**METROPOLITAN GOVERNMENT OF NASHVILLE AND DAVIDSON COUNTY**

**STAFF RECOMMENDATION**  
**1804 5<sup>th</sup> Avenue North**  
**March 17, 2021**

**Application:** New Construction—Addition and Outbuildings  
**District:** Salemtown Neighborhood Conservation Zoning Overlay  
**Council District:** 19  
**Base Zoning:** R6-A  
**Map and Parcel Number:** 08108028000  
**Applicant:** Jeff Zeitlin, Developer  
**Project Lead:** Sean Alexander, sean.alexander@nashville.gov

<p><b>Description of Project:</b> An application to construct a rear addition to an historic house and two outbuildings at the rear of the lot.</p> <p><b>Recommendation Summary:</b> Staff recommends approval of the proposed addition and outbuildings, with the following conditions:</p> <ol style="list-style-type: none"><li>1. The front gable of the roof of the addition is clipped;</li><li>2. The roof color and window and door selections are approved prior to purchase and installation; and</li><li>3. The HVAC Units are located beyond the midpoint of the building, or at the rear.</li></ol> <p>With these conditions, staff finds that the application meets the design guidelines for New Construction in the Salemtown Neighbo

SITE PLAN

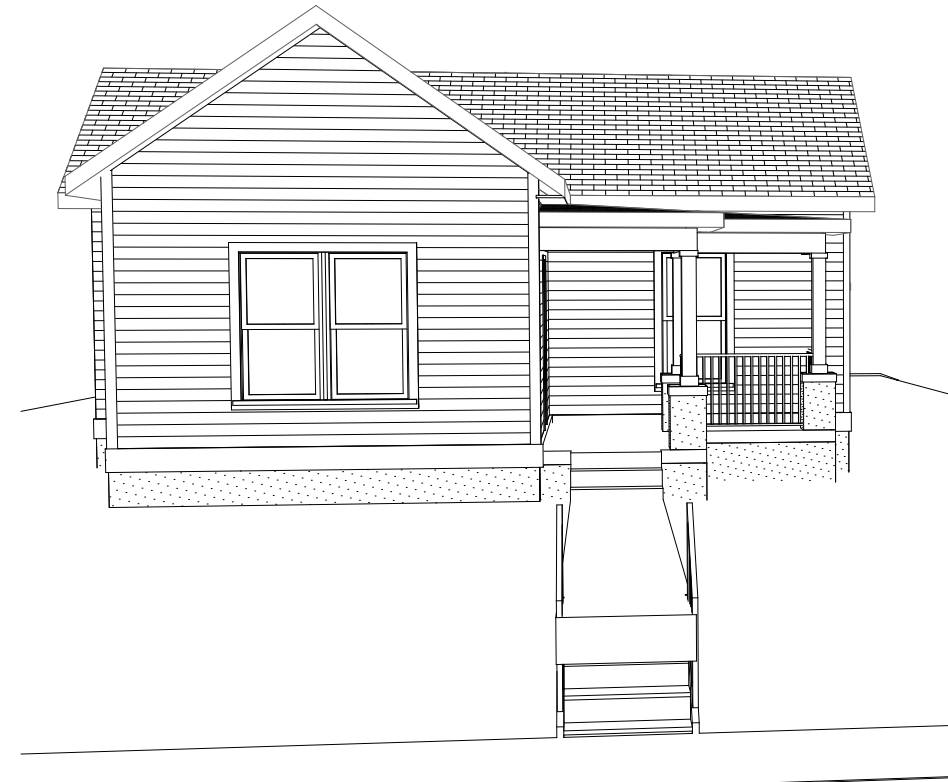
Setback & Rhythm of Spacing: With the addition matching the width of the existing house, the new construction meets the standard five foot (5') setbacks from the side property lines, and the addition will not disrupt the perceived rhythm of spacing between adjacent buildings.

Appurtenances & Utilities: The HVAC units are not indicated. Staff recommends that they shall be located beyond the midpoint of the building, or at the rear.

With the condition that the HVAC unit locations are approved, staff finds that the project meets Section III.I for site features.

ROOF PLAN

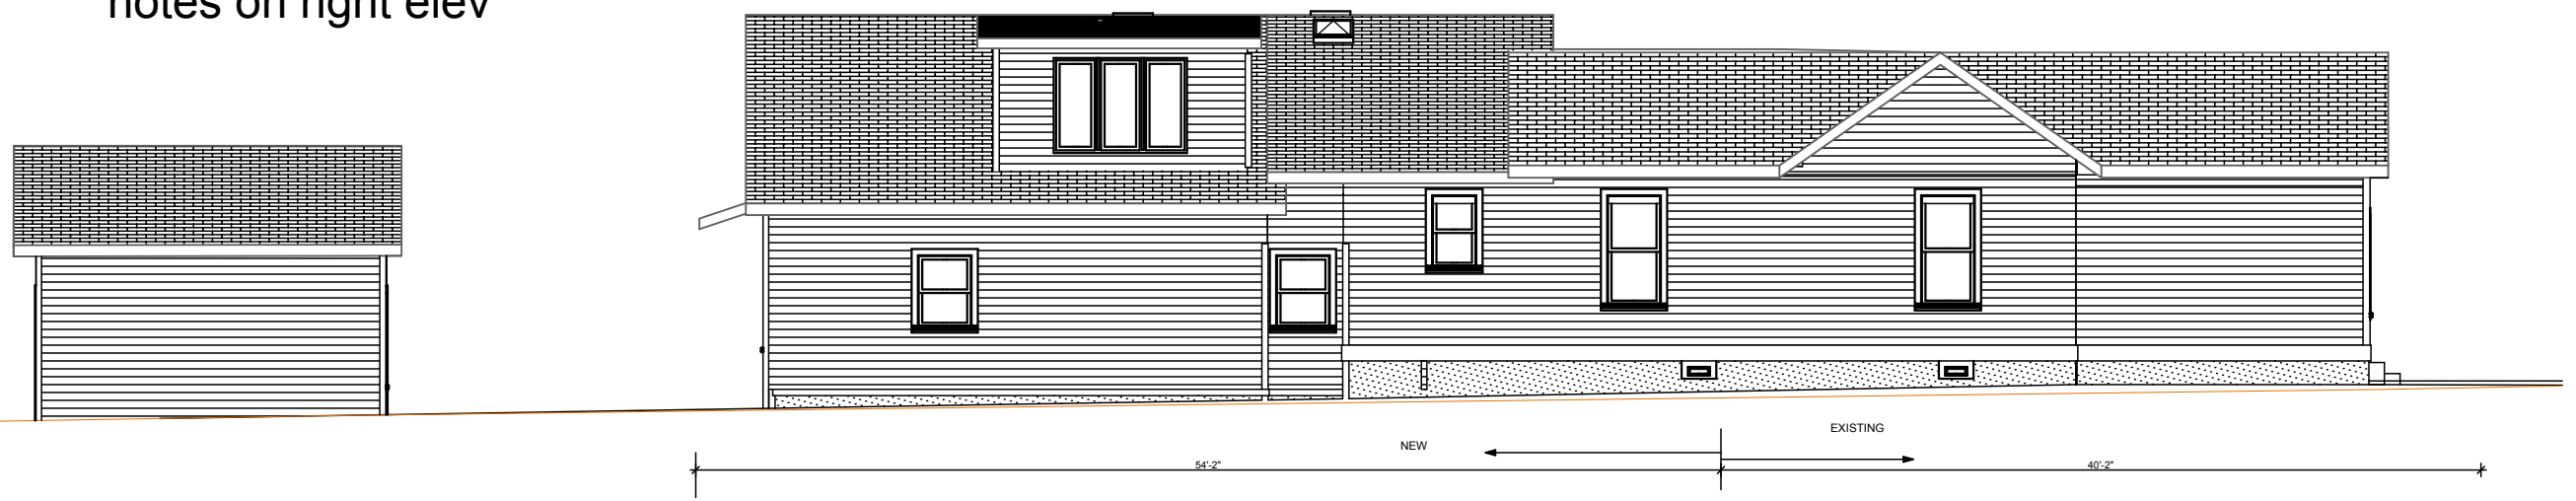
Roof form: The primary roof on the addition will be a front-oriented gable, which is compatible with the cross-gabled roof on the historic house. The pitch of the new roof will be 6/12 and 7/12, which are compatible with the historic house's 6/12 pitch. Staff recommends that the front of the addition's gable roof is clipped to help to reduce its visibility, should it be visible above the original house.

With the condition that the front of the addition's gable roof is clipped, Staff finds that the roofs of the addition meet Section II.B of the design guidelines.

1. The front gable of the roof of the addition is clipped;
2. The window and door selections shall be approved prior to purchase and installation; and
3. The HVAC Units shall be located beyond the midpoint of the building, or at the rear

ELEVATIONS 2

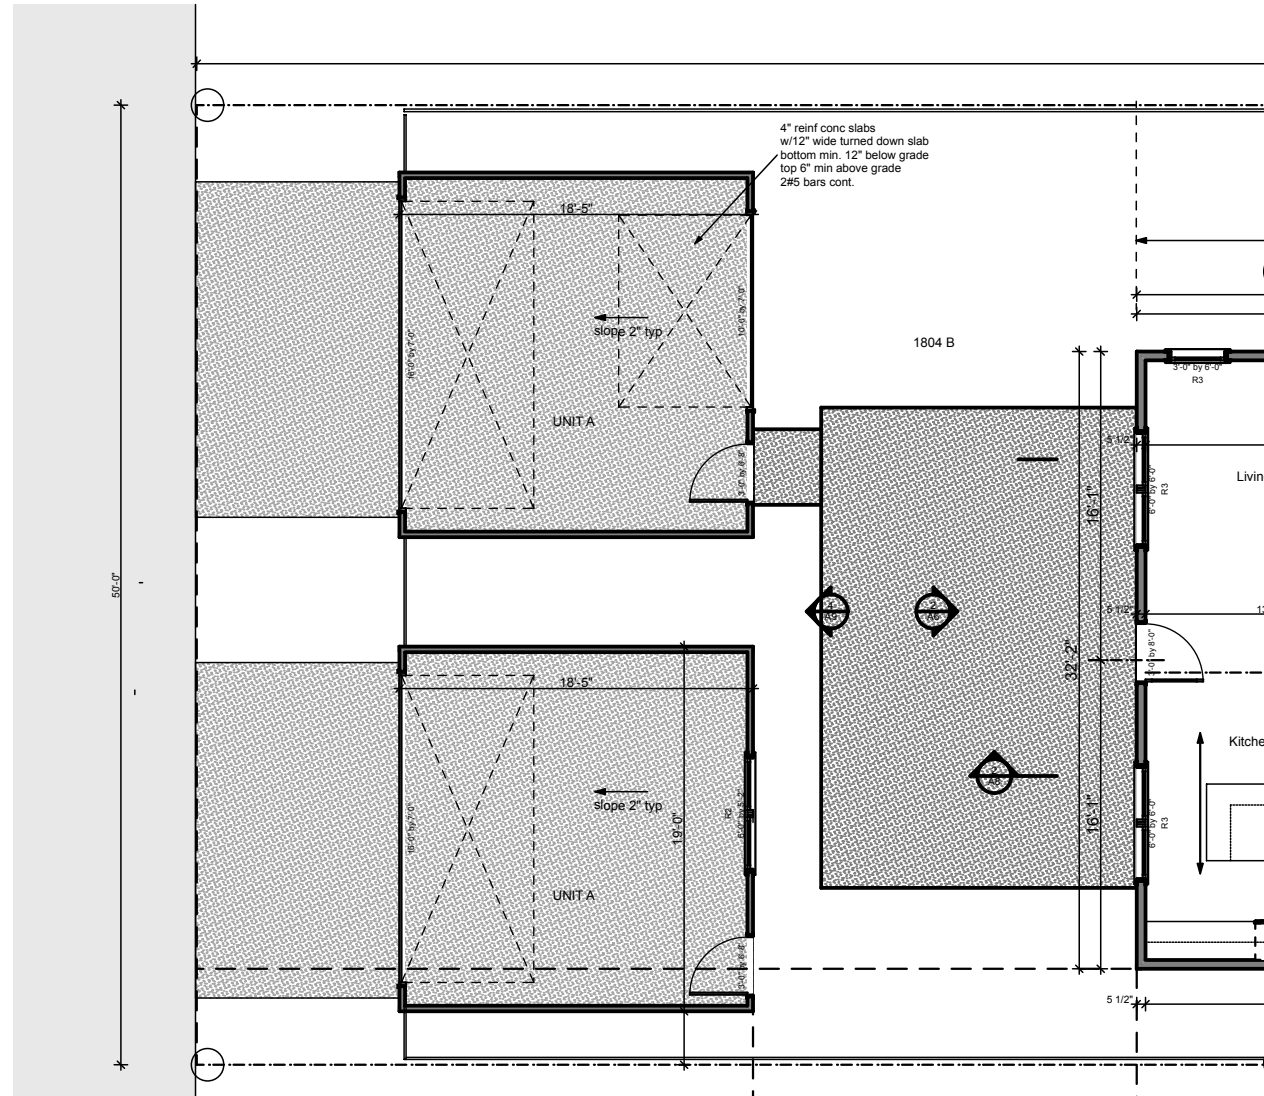
**Height & Scale:** The sides of the addition will be stepped in from the sides of the existing house by on foot (1') on each side. After a span of five feet (5'), the addition will step back out to match the width of the historic house. The roof of the house will

have a front-gabled form with a ridge height two feet (2') higher than the original roof, but an eave height two feet (2') lower than the eaves of the original roof.

Proportion and Rhythm of Openings: The submitted plans do not indicate any changes to the window and door openings on the existing house. In general, the windows on the proposed addition match the proportions of the existing windows, except for two shorter windows on the left elevation. Staff finds these windows will be compatible, as most windows exhibit a height to width ratio of 2:1 and the shorter windows are generally toward the rear. There are no large expanses of wall space on the new construction without a window or door opening.

GARAGES

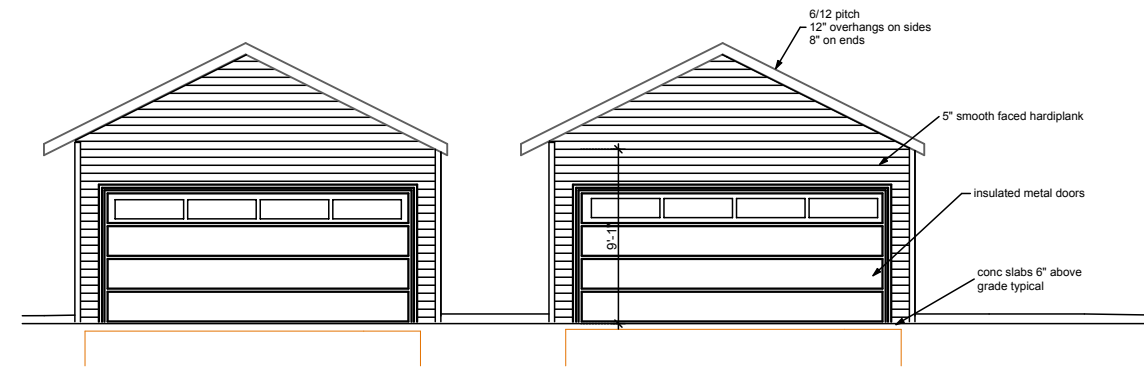
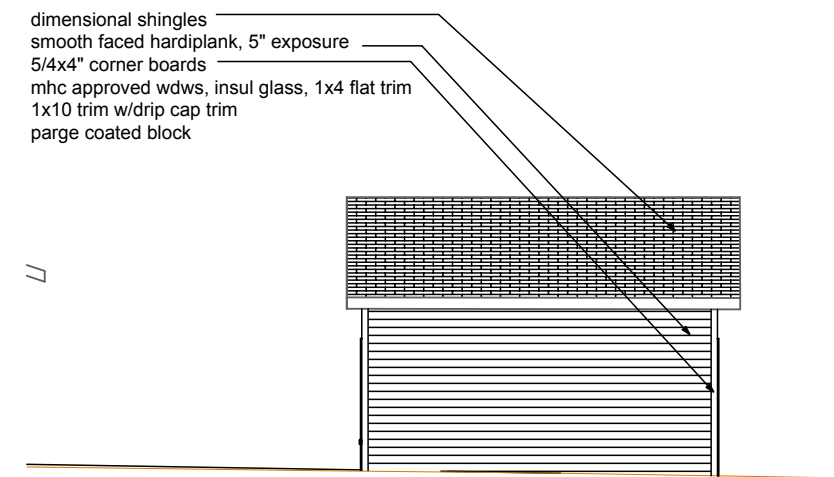
*Design Standards:* The outbuildings have a simple, utilitarian design that is appropriate for outbuildings. The outbuilding's forms, detailing, and roofs do not contrast with the primary structure and will be appropriately located at the rear of the lot.

These roof the forms and pitches are similar to historic outbuildings, therefore Staff finds that the project meets Sections III.H.1 and III.H.3 of the design guidelines.

With the staff’s final approval of the door selections, staff finds that the known materials meet sections III.H.4 and III.H.5 of the design guidelines.

<b>MINIMUM</b>	<b>PROPOSED</b>
<b>Space between principal building and DADU/Garage</b>	20'	20'
<b>Rear setback</b>	5'	11'
<b>L side setback</b>	5'	3'
<b>R side setback</b>	5'	3'
<b>How is the building accessed?</b>	From the alley	Yes

Staff finds that the location of the proposed outbuilding is compatible with the location of outbuildings historically and that it meets the setback and site planning requirements of section III.H of the design guidelines.
